SUBJECT: Advises that existing pipe configuration for vol control tank overpressure protection consistent w/appropriate ASME Code. Minor mod to V-2526 being processed, to satisfy NRC 830215 concern. Completion expected prior to core load.

March 3, 1983  
L-83-118

Re: St. Lucie Unit No. 2  
Docket No. 50-389  
Volume Control Tank  
Overpressure Protection

FIGURE 1

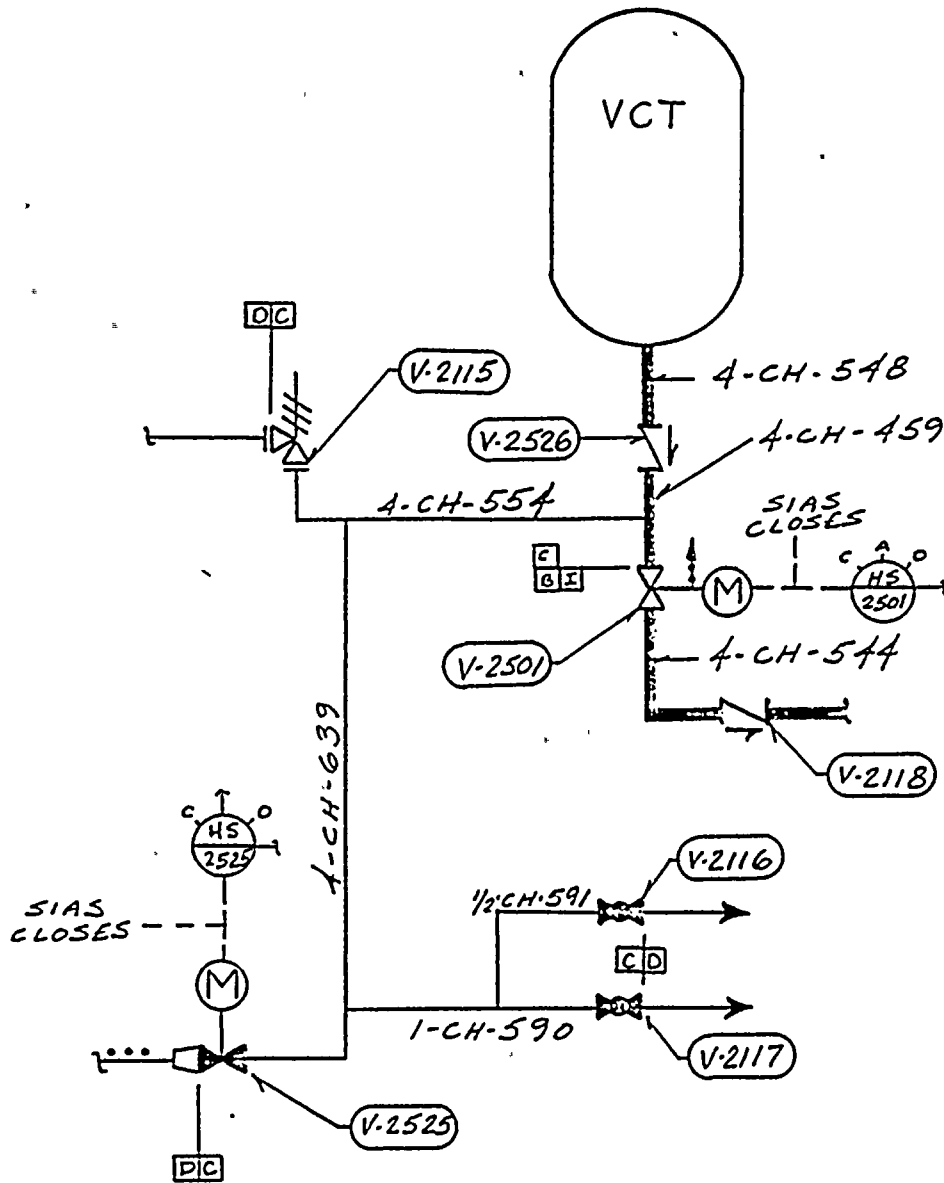
During the review of the referenced letter, the staff identified a licensing concern regarding the overpressure protection for the VCT, which is integral with the primary fill line. In subsequent discussions with your staff and in a letter dated February 15, 1983 (T. Novak to Dr. R. E. Uhrig), it was stated that the existing configuration may not be in conformance with the ASME Code.

The overpressure protection for the VCT is provided by relief valve V-2115. This valve is located on a branch line 4-CH-554 downstream of check valve V-2526 on the VCT Discharge Line, 4-CH-459. This configuration is shown in the attached Figure 1. The backfit modification, which will be completed during the first refueling outage is shown in the attached Figure 2.

While the existing piping configuration for the VCT overpressure protection is consistent with the appropriate ASME Code Requirements, FPL is in the process of implementing a minor modification that will satisfy the NRC's Code concern. So that a direct relief path can exist between the VCT and V-2115, the internals of the check valve V-2526 will temporarily be removed until completion of backfit package S1-2-BF-039, at which time the internals will be reinstalled.

This minor modification to V-2526 will not hamper the Chemical and Volume Control System's ability to provide demineralized water and it will be completed prior to core load.

FIGURE 2

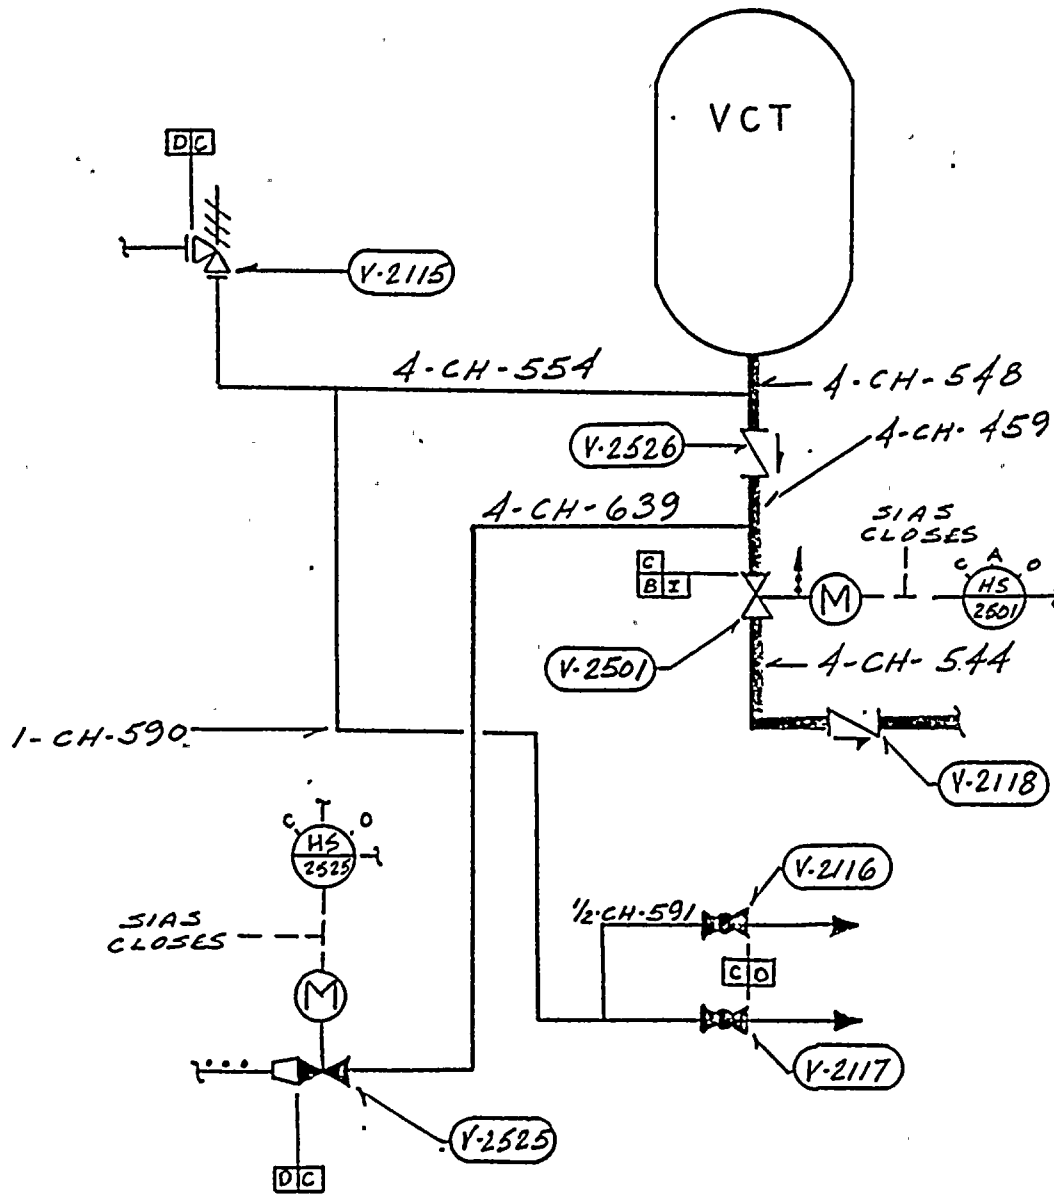
In our letter L-82-434, dated October 8, 1982, FPL addressed several items that were not to be completed by core load. One of the items was the backfit piping modification (SL-2-BF-093) to the primary fill line on the Volume Control Tank (VCT) discharge line.
